DEVELOPMENT ASSESSMENT CASE NUMBER: CD-2022-0003 – 200 E. Riverside
Planned Unit Development

COMMENT REPORT

PROJECT NAME: 200 E. Riverside

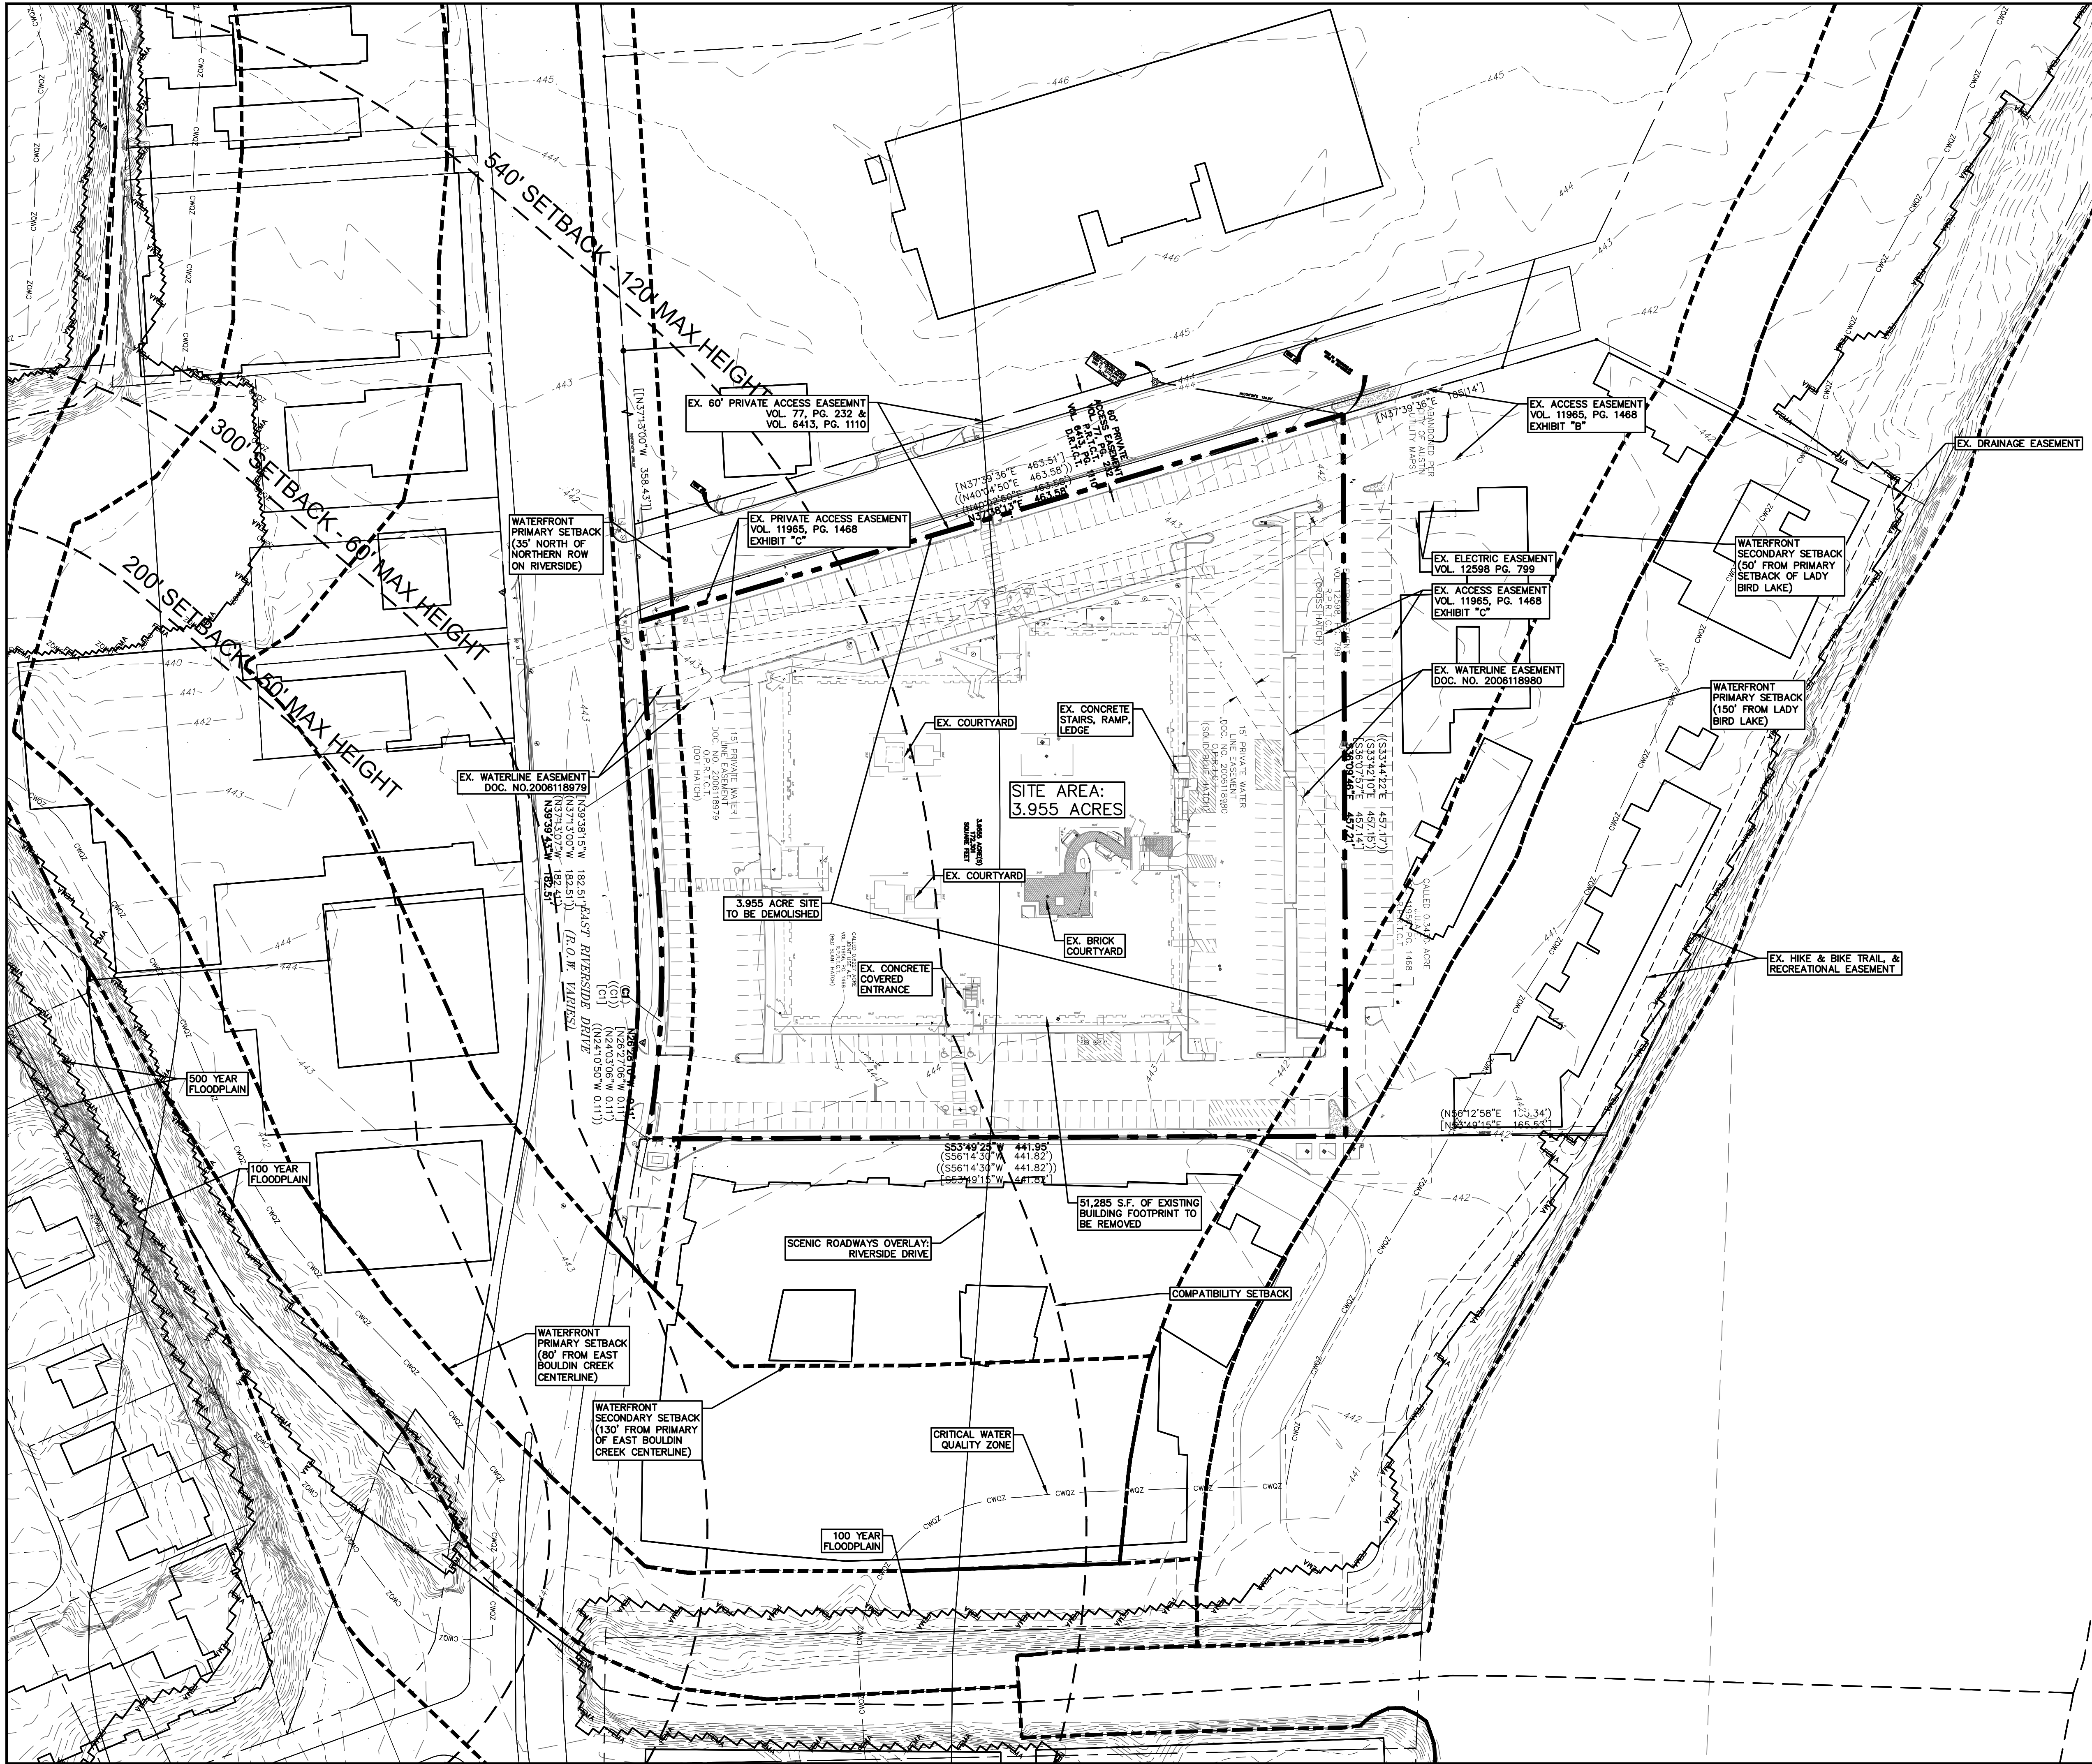
ZN 2. Label the Site Development Regulations Chart on Sheet 4 of the submittal. Clarify that the Base district is L, Lake Commercial.

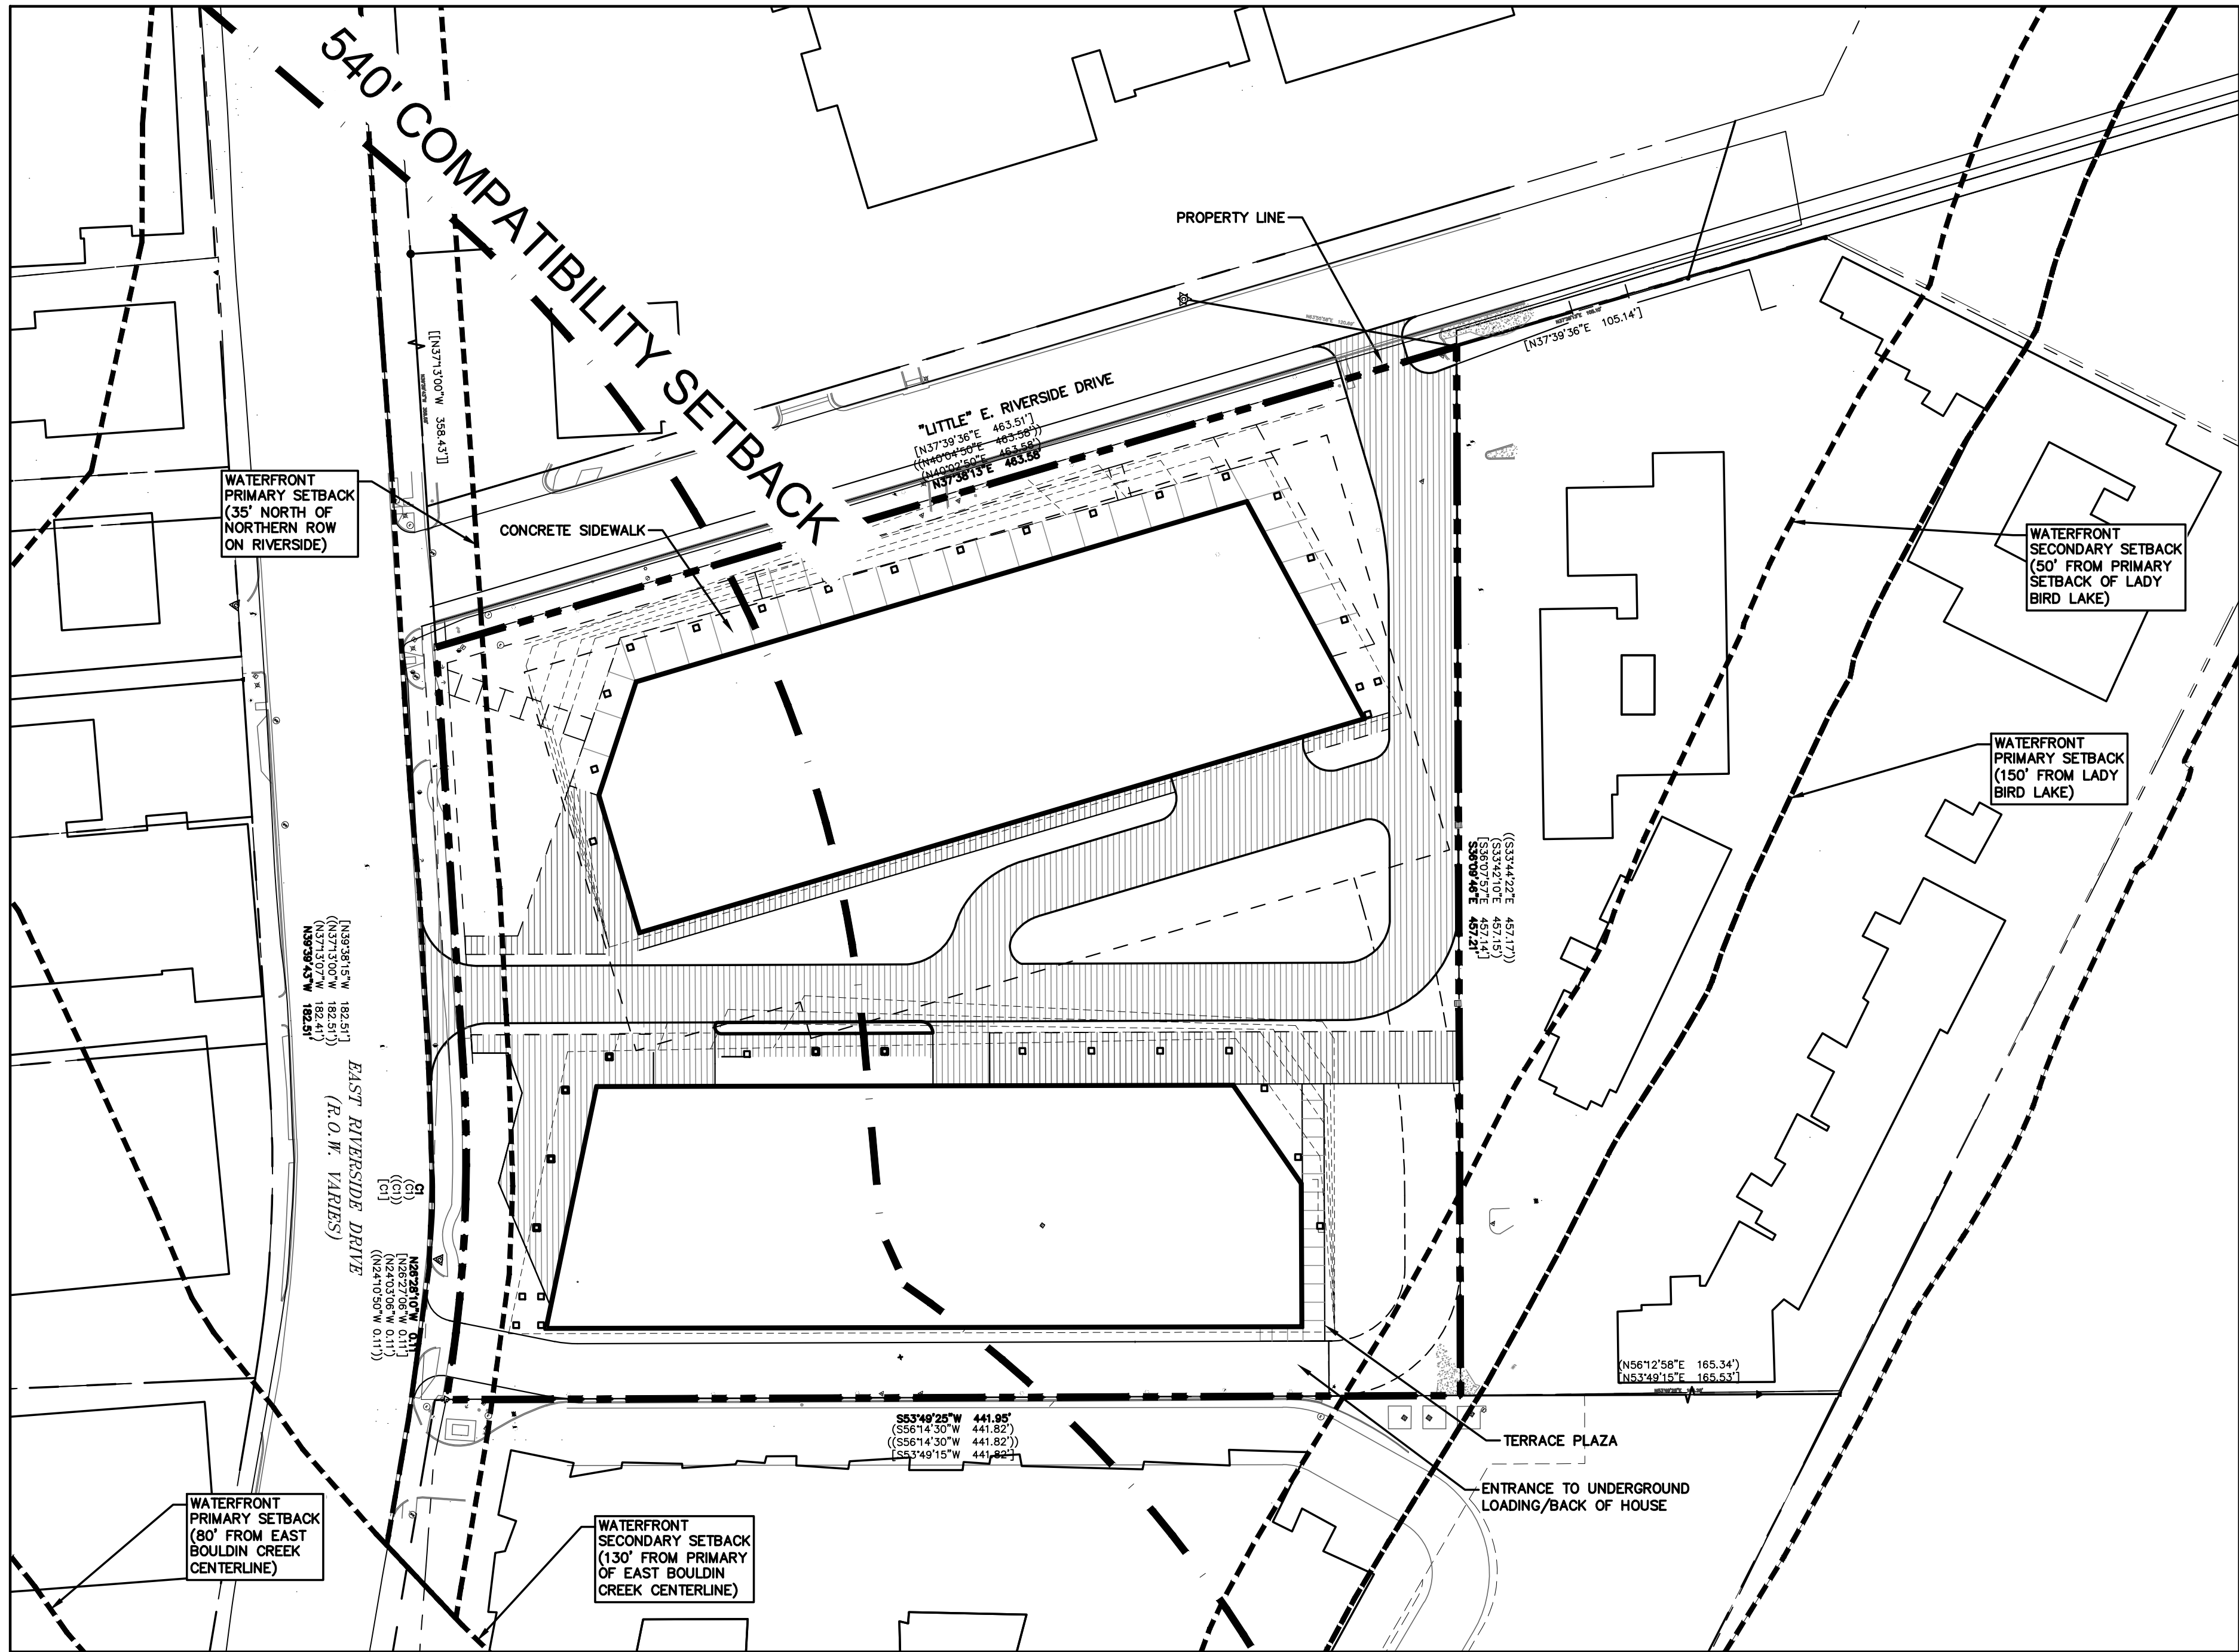
EL 1. The following note needs to be added below the Land Use Map and Data Table:
 “Electrical easements shall be required for all developments. Their location and size onsite will be determined at the subdivision plat/site plan submittal and may require more space than minimum building setback.”

EV 1 The Land Use Notes (p. 4 of the exhibits) appear to be code modification proposals. Provide them in the form of a code modification proposal, which includes a statement of the current code so that the difference between the requirement and the proposal is easily understood.

EV 2 Land Use Notes 6, 7, & 13 relate to or could relate to landscape:

- EV 3 Land Use note #25 proposes that Section 25-8-63(C)(1), pertaining to impervious cover calculations, be modified so that a parking structure can be excluded from impervious cover calculations if it is below the finished grade of the land after it is constructed.

ZN 1. Label the proposed land uses on Sheet 3 of the submittal. Identify the existing land uses and ownership of the surrounding properties.
